Request	-	Planned Unit Development for Multiple Commercial Buildings on a lot at 0 Glendale Avenue (Parcel No. 1887539)
Location	-	3015 Glendale Avenue, in southwest portion of Toledo Commons Shopping Center
Applicant	-	Ryan Finnegan Creative Self Storage 5892 Heritage Farms Drive Hilliard, OH 43026
Owner	-	Datobra Holdings LLC PO Box 983 Maumee, OH 43537
Engineer	-	Jeff Myers The Mannik & Smith Group 1800 Indian Wood Circle Maumee, OH 43537
Architect	-	Lance Heal Heal Architect 3549 N University Ave, Suite 120 Provo, UT 84604

The staff recommends that the Toledo City Plan Commission recommends approval of PUD-10003-23, a request for Planned Unit Development for Multiple Commercial Buildings on a lot at 0 Glendale Avenue (Parcel No. 1887539) to Toledo City Council for the following **two reasons**:

PLANNED UNIT DEVELOPMENT
TOLEDO CITY PLAN COMMISSION
REF: PUD-10003-23
DATE: January 11, 2024
TIME: 1:00 P.M.

PUD-10003-23

SITE PLAN

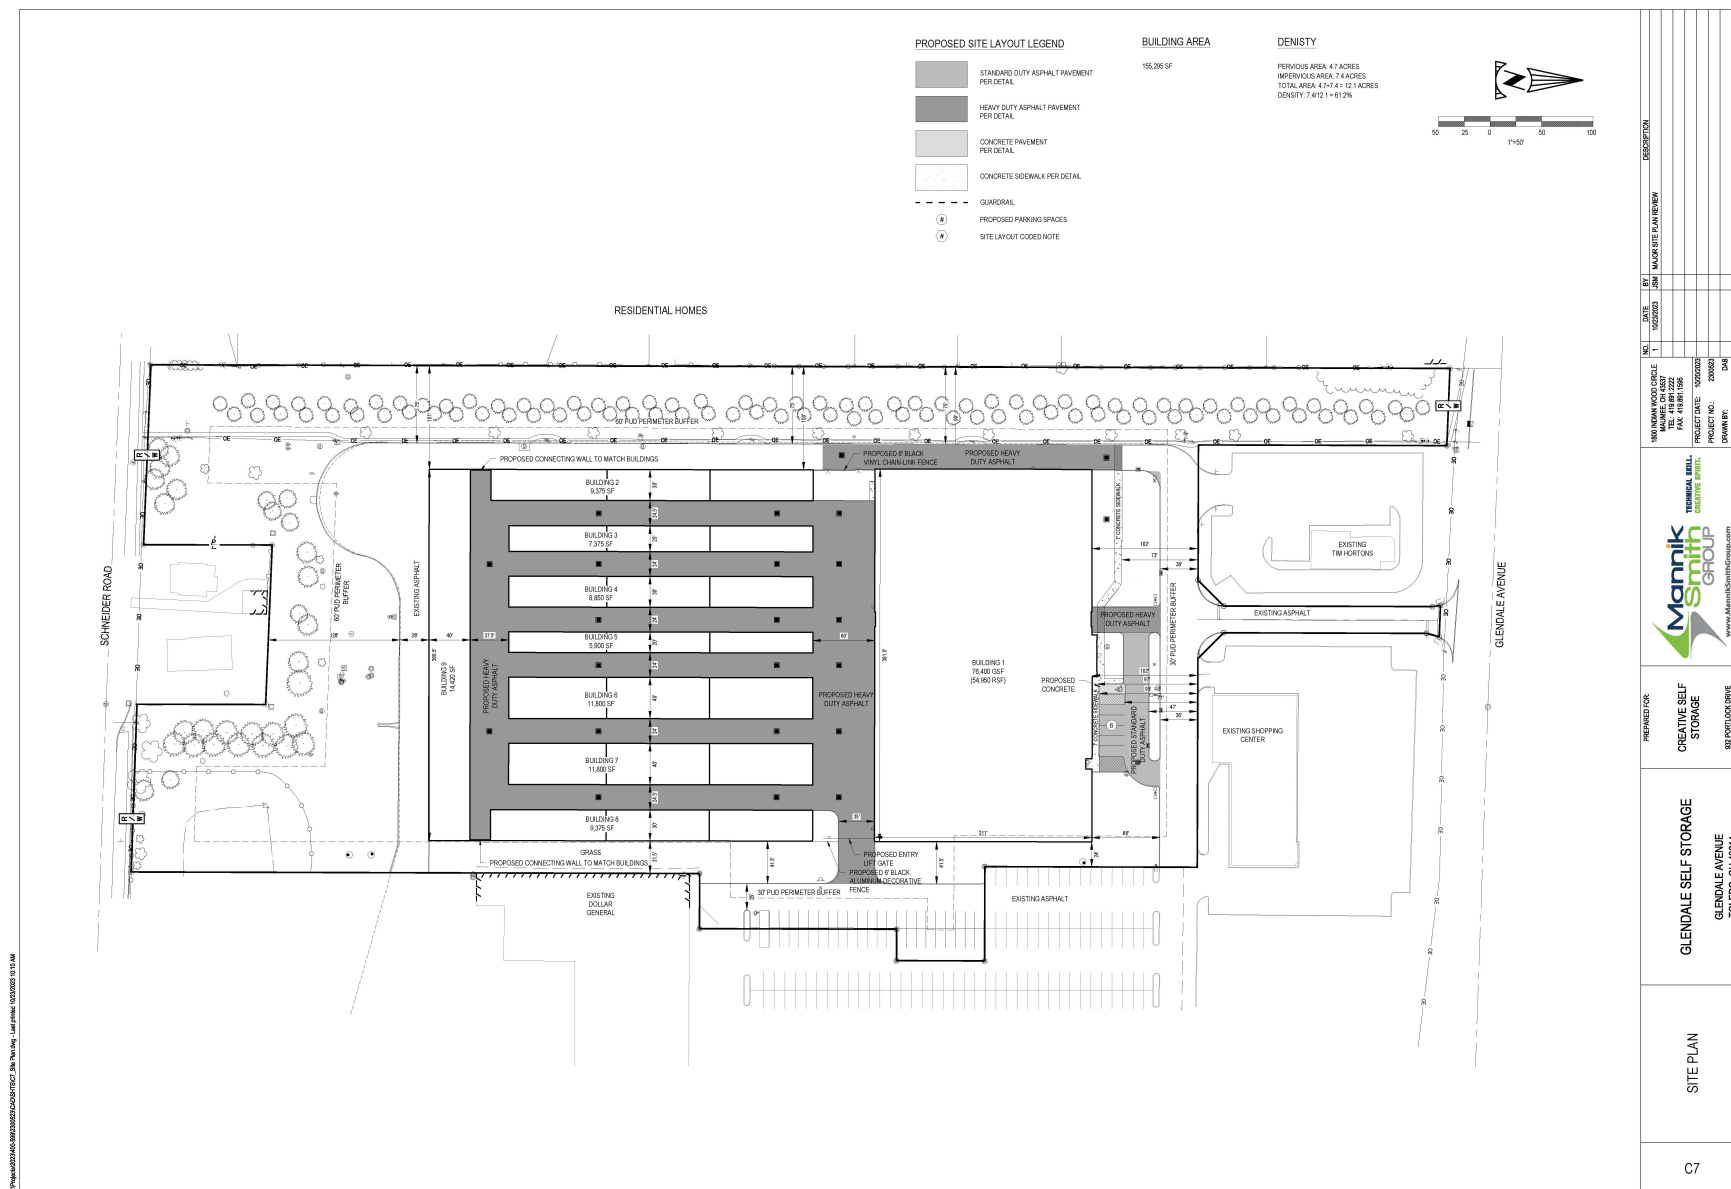
open space depth requirement with the exception of where the parking is located. In this case there is a proposed landscape island with grasses, shrubs and trees; however, it is not 30 feet in width. A waiver is thus required for the 30-foot depth open space requirement along this portion of the north perimeter.

6-foot black aluminum fence and entry lift gate between Building 1 and Building 8 and on the west side with a 6-foot black vinyl chain-link fence between Building 1 and Building 2. In addition, a 6-foot wall that matches the outdoor storage buildings is proposed to connect Building 9 and Building 8 on the east and Building 9 and Building 2 on the west. Staff recommends that both sections of fencing be the proposed 6-foot black aluminum fencing.

Upon review of the submitted plan, the Division of Transportation noted that 25-foot driveways and drive aisles are required for two-way traffic per TMC§1107.1911. The drive aisles between the outdoor storage buildings (Building 2 - Building 8) do not meet this requirement. The aisles as proposed vary from 24 feet to 24.5 feet in width. In a discussion with the Division of Transportation, it was determined that the deficiency of a half of foot to one foot in aisle width would be acceptable in this circumstance. This determination was based on the type of use and the fact that the site will not be open to the general public, but limited to renters of the storage units.

- Per TMC§1107.0304 a self-storage facility is required to have 4 parking spaces plus 1 parking space per 250 rental spaces. There are a total of 922 storage units, which equates to 4 spaces, for a total requirement of 8 parking spaces. Based on these 8 required spaces, 2 bicycle spaces are required and 1 accessible van space (TMC§1107.1701). The site plan illustrates 6 parking spaces at the front of the building, one of which is an accessible van space. Additional spaces are provided to the east that are in excess of the required 8 spaces; therefore, the proposal is in compliance with the minimum number of required off-street parking spaces. Bicycle parking is however not provided. A provision for 2 bicycle parking spaces is needed to meet this requirement.

- Per TMC§1103.1010(D) PUD developments are required to provide sidewalks, built to city specifications along both sides of all streets, public or private. Sidewalks or other approved pedestrian walkways must be provided to link nonresidential areas with residential areas, both inside and outside the PUD. The proposal is providing for a sidewalk in front of Building 1 from the entry, north to an existing sidewalk along the west property line, that extends from Glendale Avenue to Schneider Road. To complete this connection, a sidewalk needs to be provided from the entry east to the edge of the property, to connect to the existing shopping center. This will provide for access to the existing parking spaces to the east.

35. The material for both the proposed 6-foot black vinyl chain-link fence and the 6-foot black aluminum decorative fence and entry gate shall be the same. The fences and entry gate shall be decorative black aluminum and shown as such on a revised site plan and landscape plan.

36. Per TMC§1107.0304, the Off-Street Parking Schedule requires one bicycle parking slot per 10 parking slots. No bicycling parking is proposed. A minimum of two bicycling slots shall be shown on a revised site plan.

37. Per TMC§1103.1010(D) PUD developments are required to provide sidewalks, built to city specifications along both sides of all streets, public or private. Sidewalks or other approved pedestrian walkways must be provided to link nonresidential areas with residential areas, both inside and outside the PUD. To provide a complete connection, a sidewalk shall be provided from the front entry of Building 1, east to the edge of the property, to connect to the existing shopping center. The sidewalk shall be shown on a revised site plan.

Approve a waiver to allow for open space reduction below the required 30 feet depth along the north portion of the development where the parking, drive aisle and landscape island is proposed. For the east portion of the site where the minimum 30-foot open space depth is not met, Staff recommends that a waiver not be approved at this time and the Applicant continue to work to obtain the additional area required.

LANDSCAPE PLAN

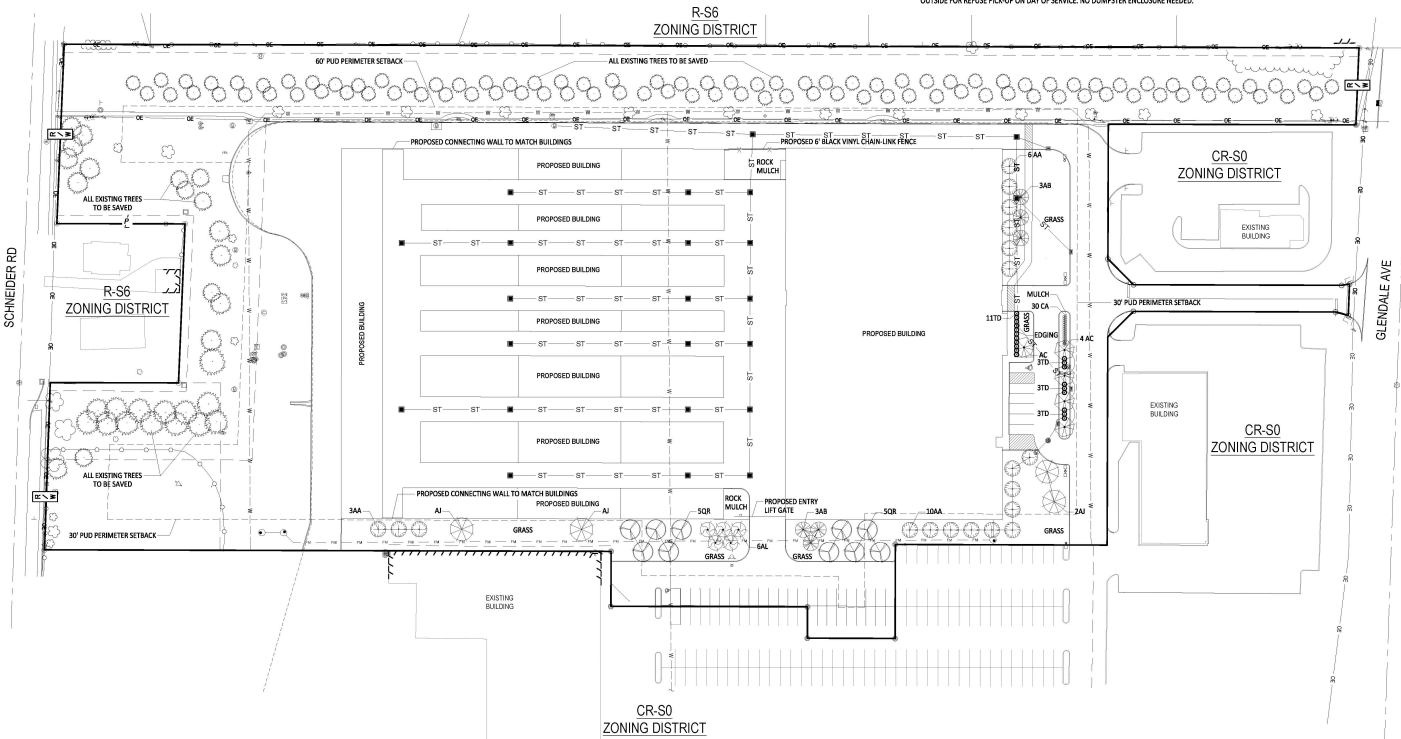
- Per TMC§1108.0205(B) in addition to the other landscape requirements for buffer areas, frontage greenbelts, and landscaping for parking lot areas, the following shall be provided: one 2-inch caliper tree for every 1,000 square feet of building coverage (footprint); foundation plantings along all portions of the building that are visible from the public rights-of-way; and landscaping at all major building entrances. The total square feet of building coverage is equal to 155,295 square feet. This translates into the need for 156 trees in the interior of the development as well as foundation plantings along the north and east side of Building 1. Foundation plantings in the form of shrubs and trees (shade and flowering) are provided along the north and east facades of Building 1. In addition, both shade and flowering trees are proposed along the east side of Building 8. Currently however, no interior trees or landscape areas are provided. There are two areas noted on the landscape plan as “rock mulch”. Rock mulch is not permitted and will need to be shredded hardwood mulch. One interior tree shall be provided in the area between Building 1 and Building 2 where “rock mulch” is noted. A waiver is required for the interior landscape as proposed. The developer is requesting a waiver from the interior landscape requirement due to the nature of the self-storage business land use.

Interior tree requirement not acceptable as depicted. One interior tree shall be provided in the area between Building 1 and Building 2 where “rock mulch” is noted. In addition, the Applicant shall obtain a waiver of the other required 155 interior trees.

- e. Per TMC§1108.0204(B.6), landscaped areas may not contain bare soil, aggregated stone, or decorative rock. Any ground area must be covered with hardwood mulch, grass, or other vegetative ground coverage. The proposed rock mulch is not permitted. **All areas that are noted as “rock mulch”, shall be hardwood mulch.**

Approve waiver to not provide the required interior trees except for one tree to be placed in the area on the submitted landscape plan, between Building 1 and Building 2, where “rock mulch” is noted. Approval of the waiver is due to the fact that the nature of a self-storage facility is to provide storage area that translates to building area for which this standard is based.

PRELIMINARY
EXTERIOR
ELEVATIONS

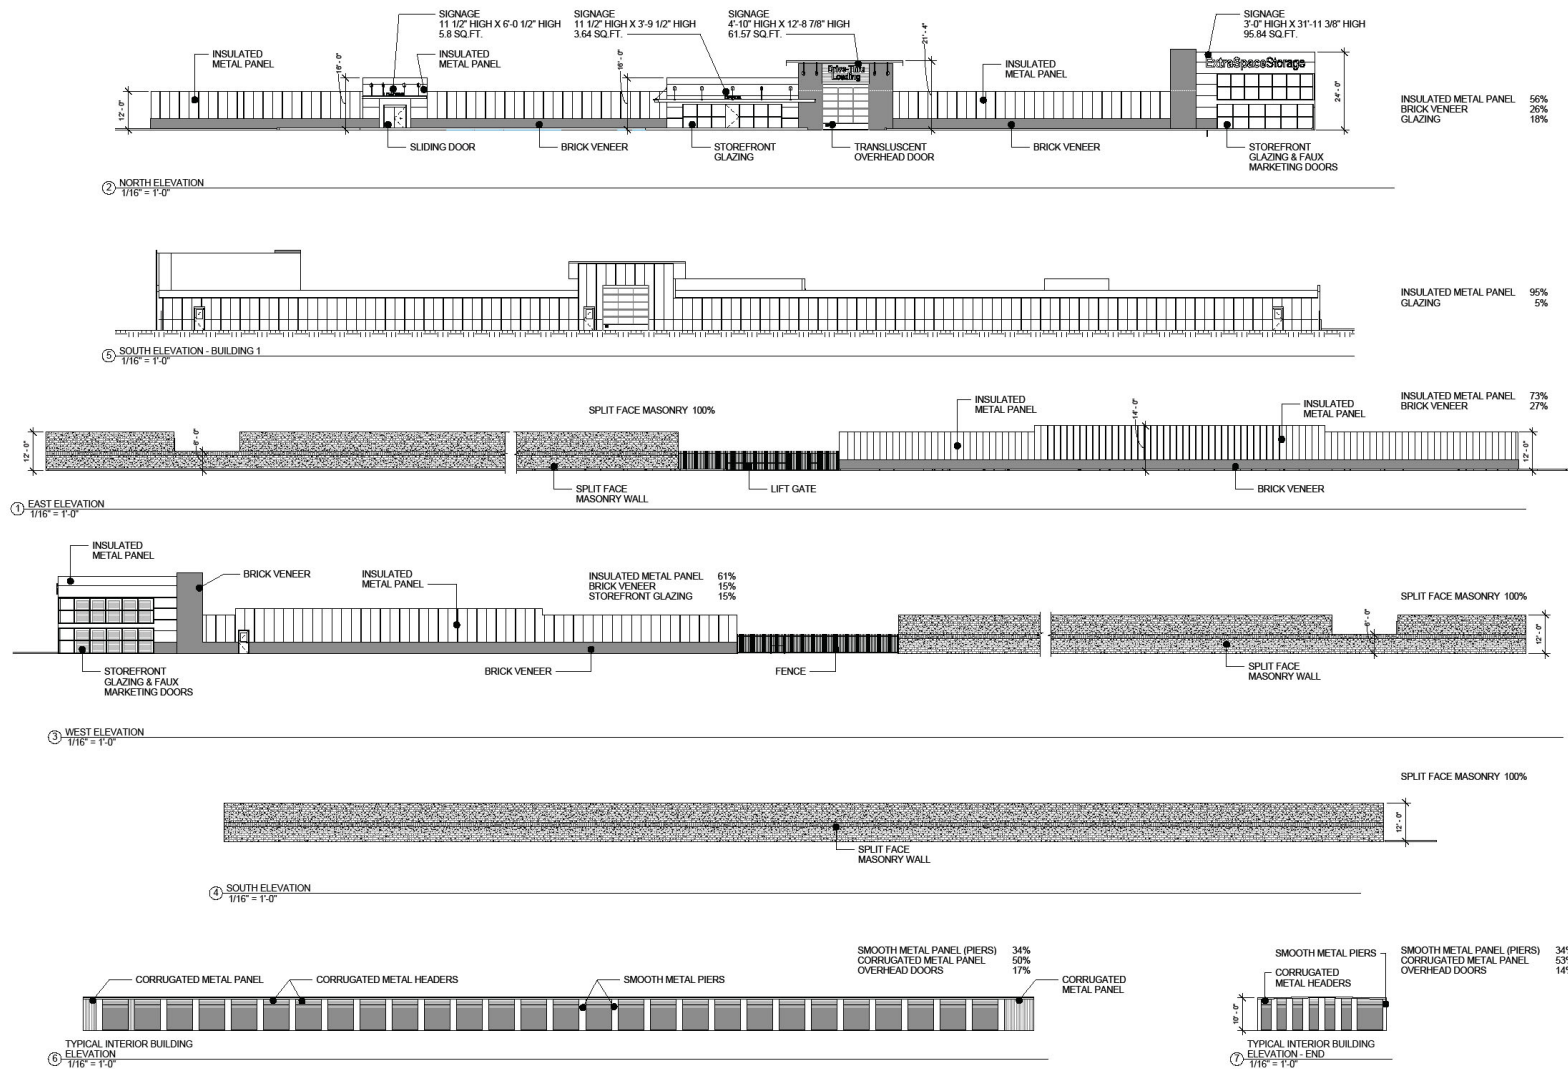
The building design is subject to the standards outlined in TMC§1109 – Design Standards. This review includes consideration of the following elements: scale and proportion, suitability of building materials, design in relation to surrounding area and buildings, design in relation to proposed landscaping, and aesthetics of proposed buildings. The front or north façade of Building 1 and the east facades of Building 1 and Building 8 are the predominant facades visible from a public right-of-way. The front facade of Building 1 does provide for variations in height, material and wall articulation. The east facade of Building 1 and Building 8 provide very limited variation or visual interest. Visual interest could be improved by providing for differing colors for the proposed building materials. As a note, the visual interest of the east façade could be improved if the noted “storefront glazing and faux marketing doors”, located at the northwest corner of Building 1, was switched to the northeast corner. This would also provide public view of the Applicant’s “marketing tool” from the adjacent commercial parcels. As proposed, this part of the west elevation abuts the west landscape buffer of the site, where it lacks visibility. Revised building elevations need to be submitted with building materials and material colors noted.

Per TMC§1109.0500 building material standards apply to all facades that are visible from the right-of-way and building color standards apply to all exterior elevations regardless of right-of-way visibility. A full breakdown of the proposed materials is included in the conditions of approval. As shown, the materials do not meet the requirements of TMC§1109.0502. A waiver from the building material standards will be required. Since Building 8 is visible from public view, this building shall be constructed of brick, not split face masonry as noted on the exterior elevations. Staff has reviewed the proposed insulated metal panel and it is consistent with permitted architectural metals, provided the face sheet of the panel is the 22 gauge option. To ensure that the building facades meet the design standards, revised elevations with revised materials and colors shall be submitted.

- a. Building 1 - The north elevation depicts 56% Insulated Metal Panel, 26% Brick Veneer, and 18% Glazing. The south elevation depicts 95% Insulated Metal Panel and 5% glazing. The west elevation depicts 61% Insulated Panel, 15% Brick Veneer, and 15% Storefront Glazing. The east elevation depicts 73% Insulated Metal Panel and 27% Brick Veneer. The predominant material for all of these elevations is Insulated Metal Panel. **Acceptable as depicted, provided the provided the face sheet of the insulated metal panel is the 22 gauge option.**

- b. Building 2 – The west elevation depicts 100% Split Face Masonry. A detail for the north and south elevations were not provided. These elevations should also be split face masonry. The east elevation will consist mainly of overhead doors separated by smooth metal piers, with corrugated metal headers along the top of the building

- d. Building 8 - The east elevation depicts 100% Split Face Masonry. A detail for the north and south elevations were not provided. The west elevation will consist mainly of overhead doors separated by smooth metal piers, with corrugated metal headers along the top of the building façade, and corrugated metal panels framing the ends of the building facade. Split face masonry is not allowed as a predominant building material. **Since this building is visible from a right-of-way, it shall be constructed on brick with the exception of the west elevation. A typical detail for the north and south elevations for this building shall be submitted.**

- e. Building 9 - The south, west and east elevations depict 100% Split Face Masonry. The north elevation will consist mainly of overhead doors separated by smooth metal piers, with corrugated metal headers along the top of the building façade, and corrugated metal panels framing the ends of the building facade. Split face masonry is not allowed as a predominant building material. While this building faces a right-of-way on the south, it is not visible with the existing landscape buffer in place. Therefore, staff supports a waiver from the material requirement. **The Applicant shall obtain a waiver for building material on the south elevation.** The east elevation of Building 9 is connected via a 6-foot-high wall to Building 8. **The 6-foot-high wall as well as the east elevation of Building 9 shall be constructed of brick to match the east elevation of Building 8.**

- f. The elevations do not indicate the color for the proposed materials. Revised elevation drawings will shall be submitted to reflect not only the material changes, but also color of all materials. All revisions must be in compliance with TMC§1109 – Design Standards.

Approve waiver for the predominant building material for Building 9 to be split face masonry. While this building faces a right-of-way it is not visible with the existing landscape buffer in place.
